**Eugene School District 4J
ROOSEVELT MIDDLE SCHOOL**
680 East 24th Avenue
Eugene, OR 97405
CIP No. 410.566.001

ADDENDUM NO. 6

This Addendum forms a part of the Contract Documents and modifies the original Bidding Documents dated February 18, 2015 and subsequent addenda as noted below. Acknowledge receipt of this Addendum in the space provided on the Bid Form. Failure to do so may subject the Bidder to disqualification.

P-121C

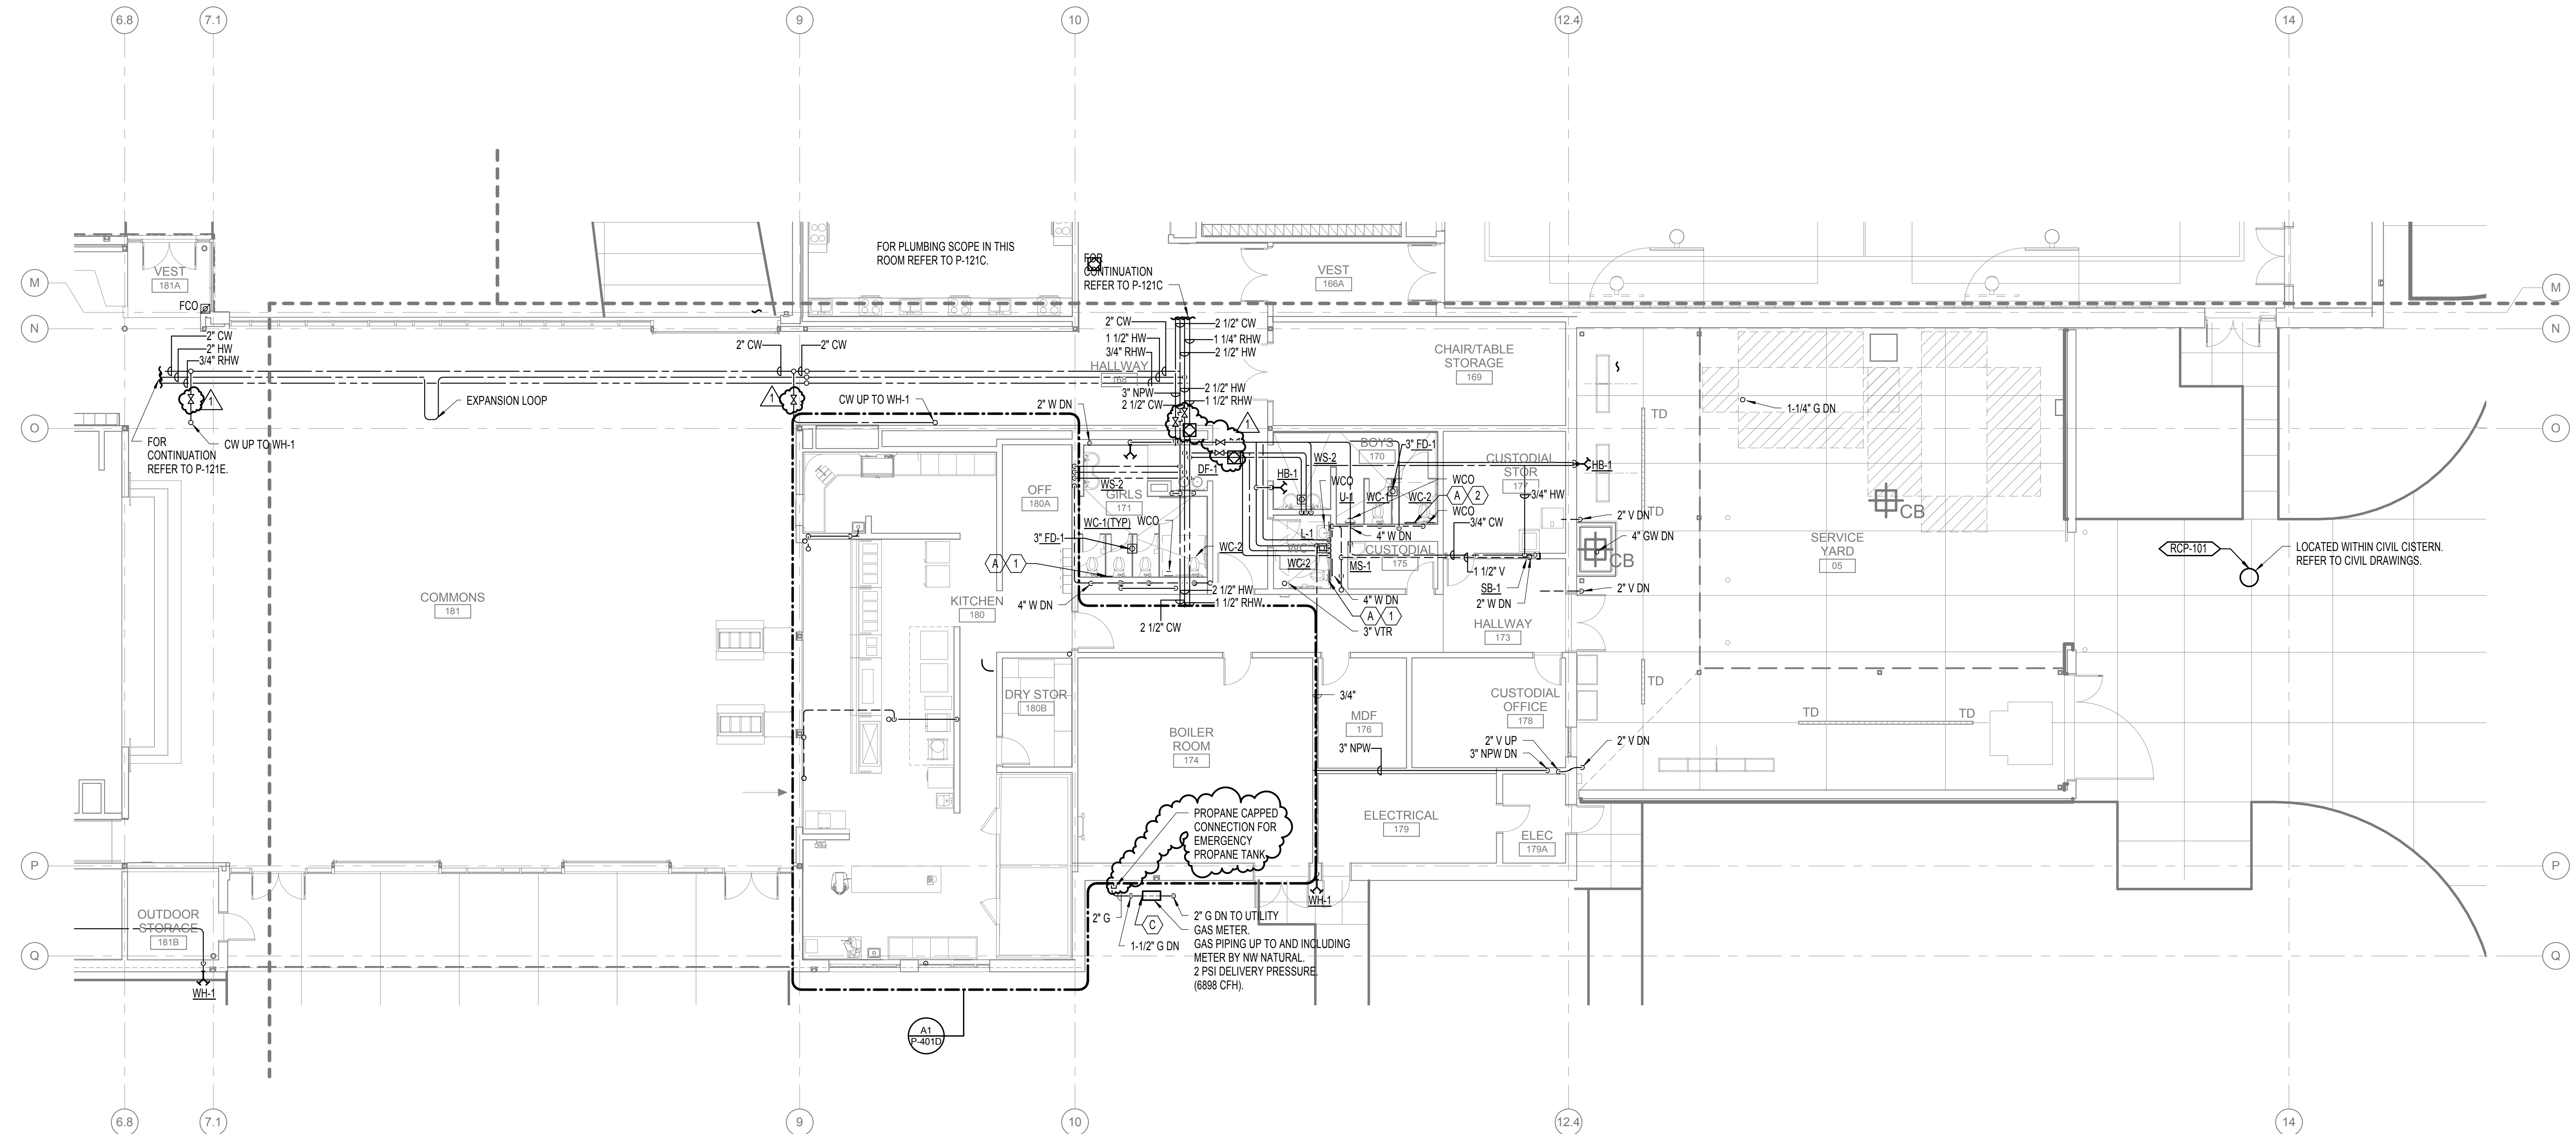
- A. Replace Sheet with revised Sheet P-121C: Add isolation valves and balancing valves

FIRST FLOOR PLAN - ZONE E - PLUMBING

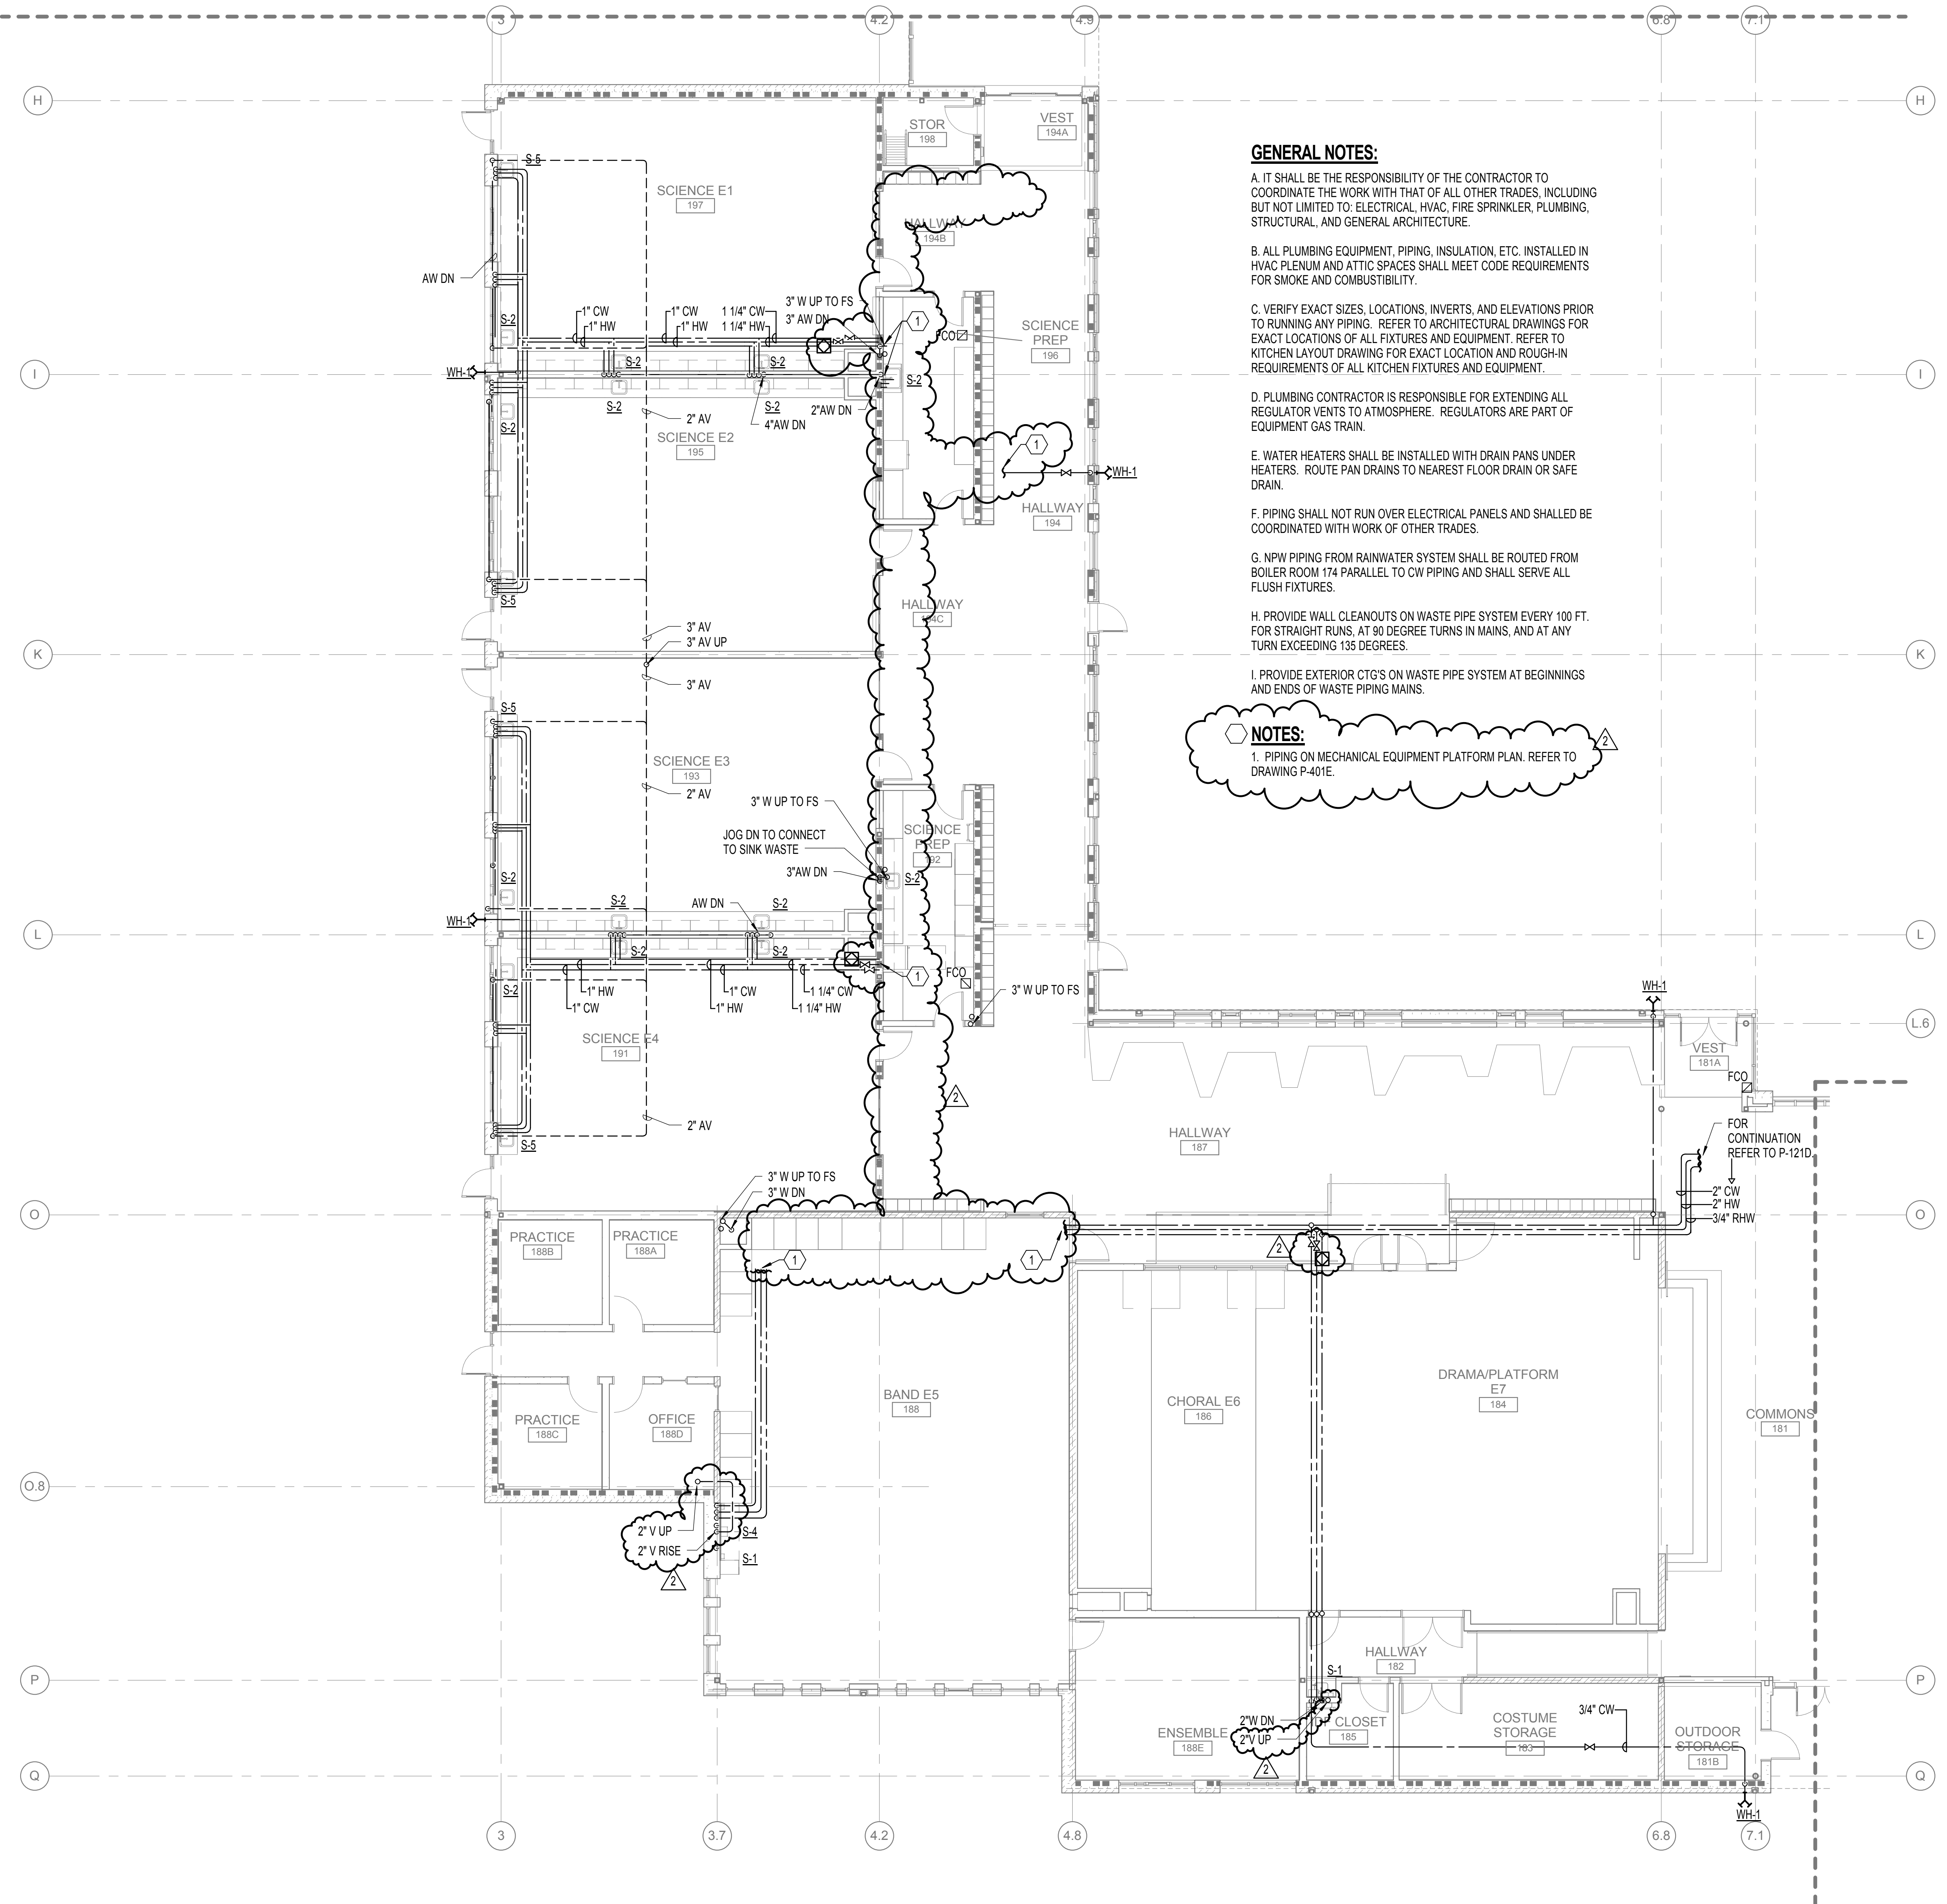
- A. Replace Sheet with revised Sheet P-121E: Add isolation valves and balancing valves. Add notes clarifying pipe locations. Add vent piping to band room and hallway 182 sinks.

A1 SECOND FLOOR PLAN - ZONE A - PLUMBING
 1/8" = 1'-0"

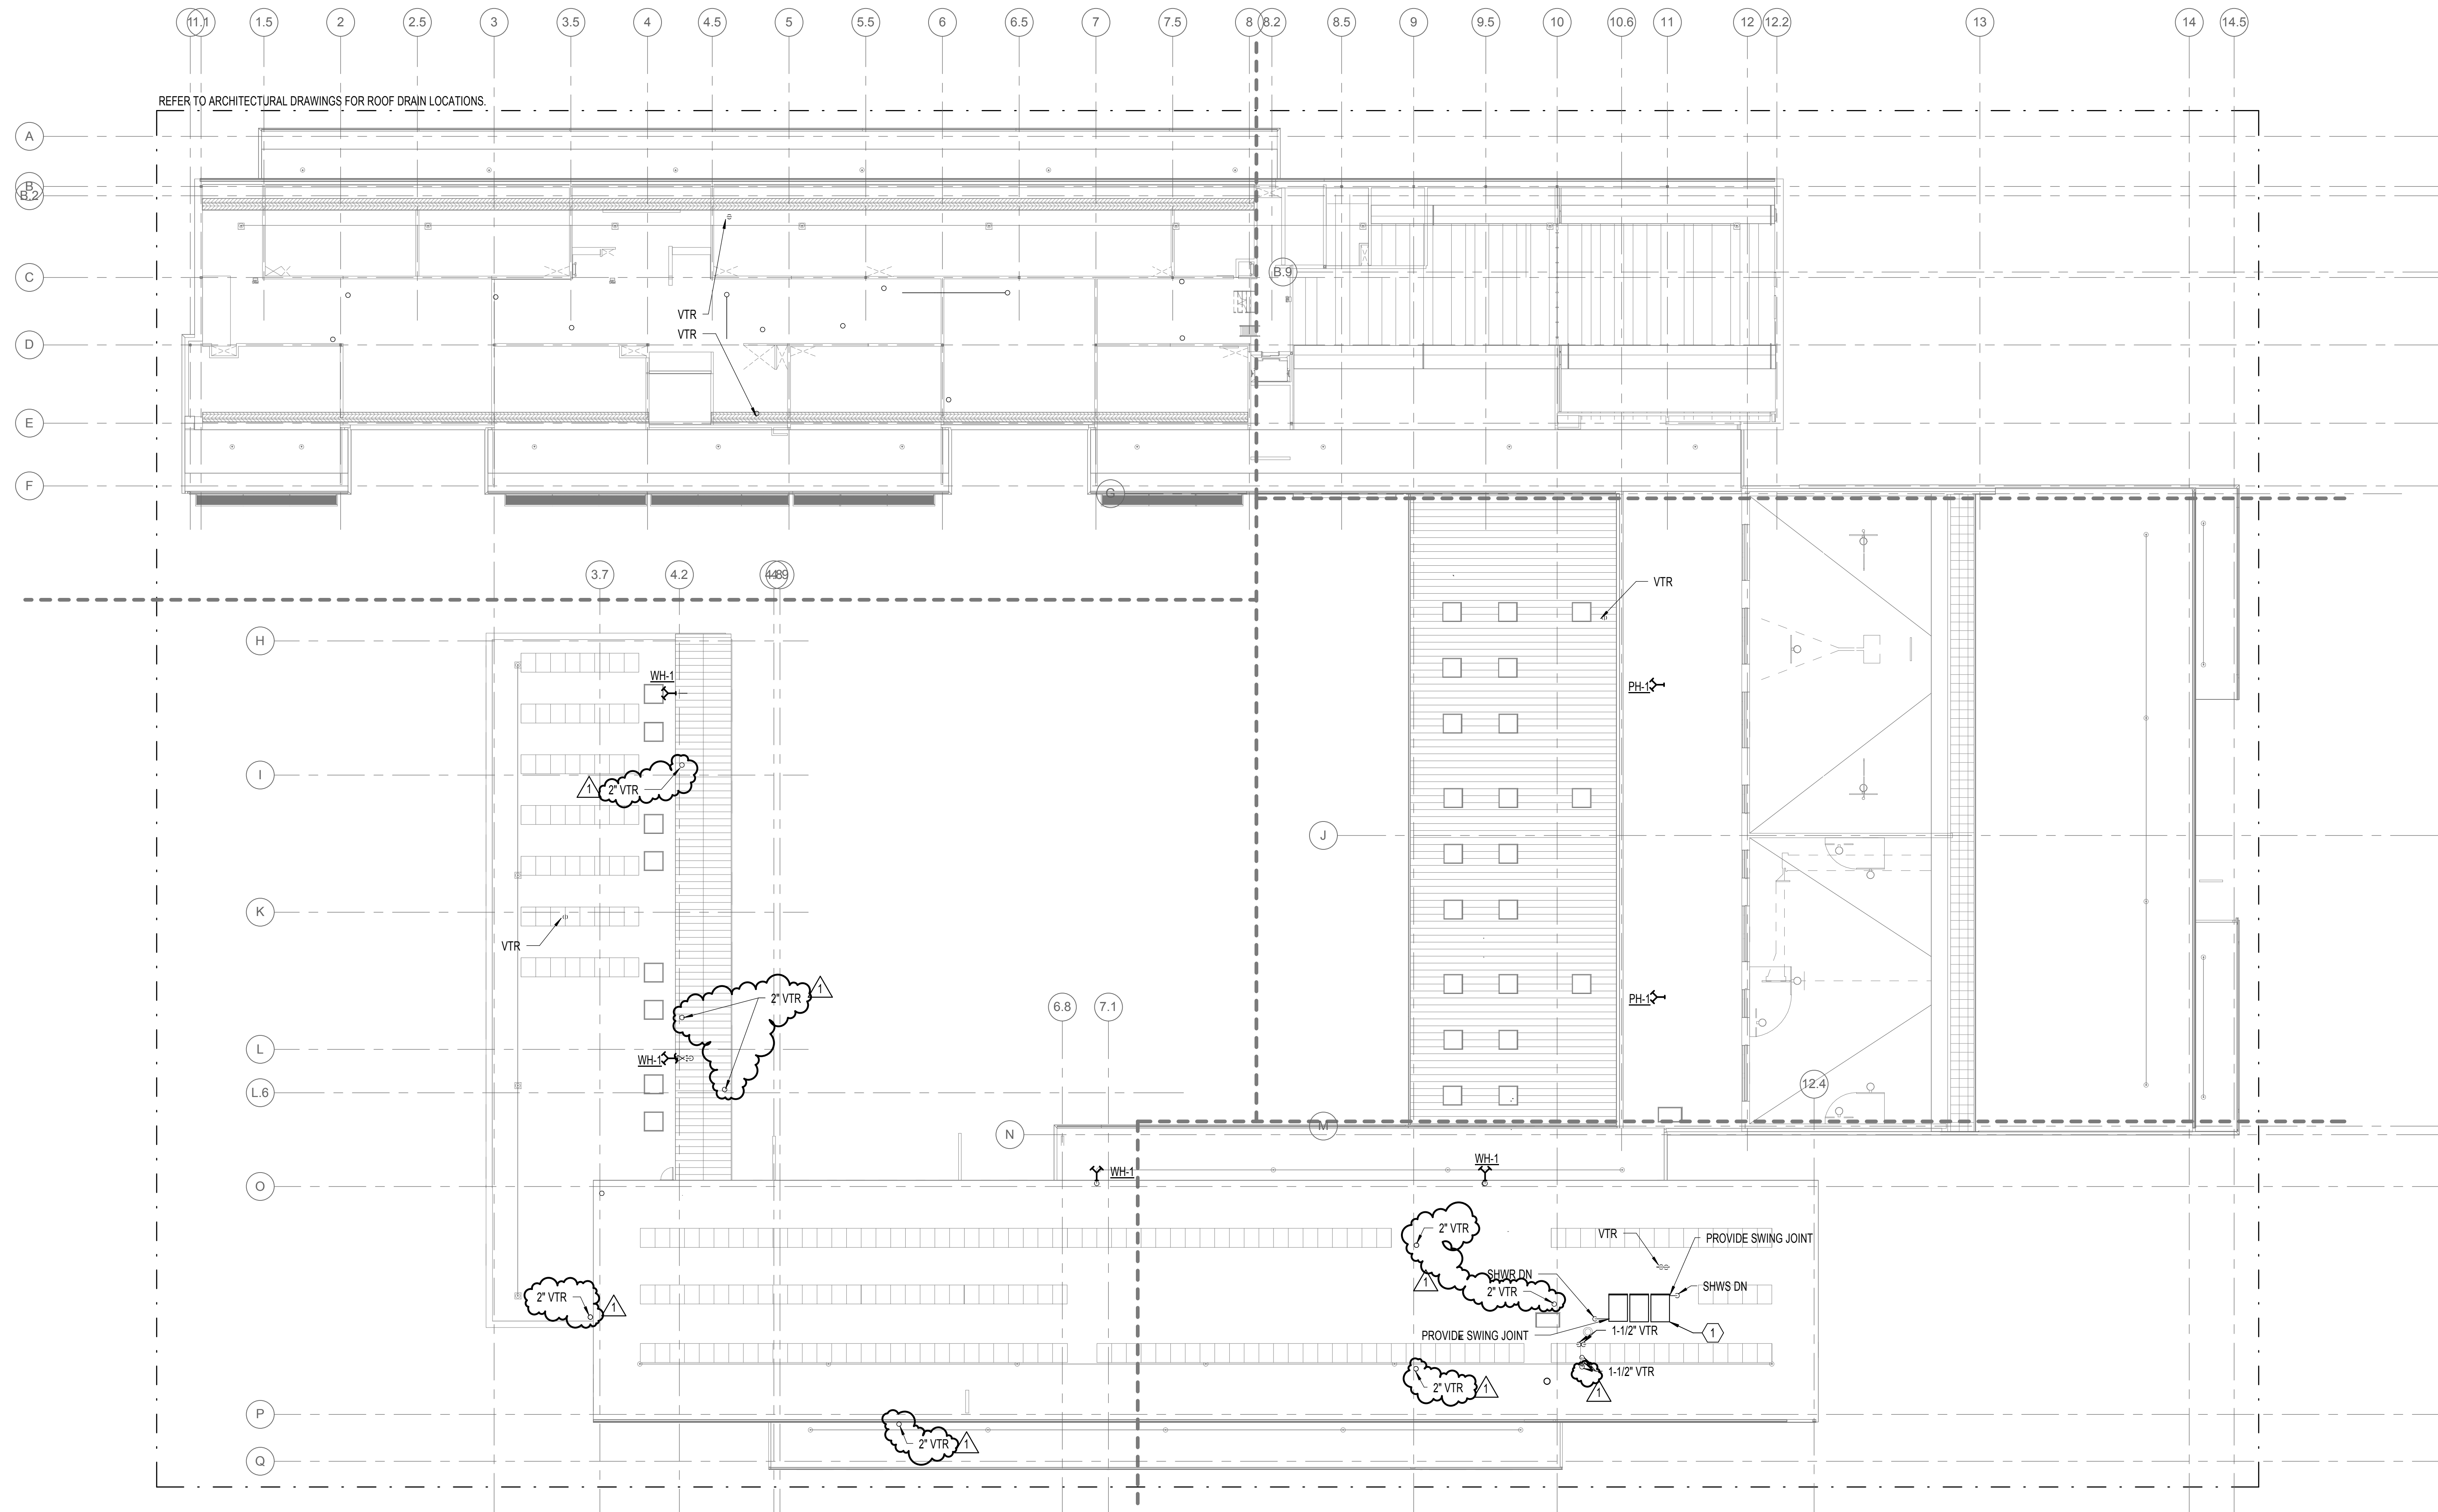
- A. Replace Sheet with revised Sheet P-122A: Add dishwasher connection at Lounge 209
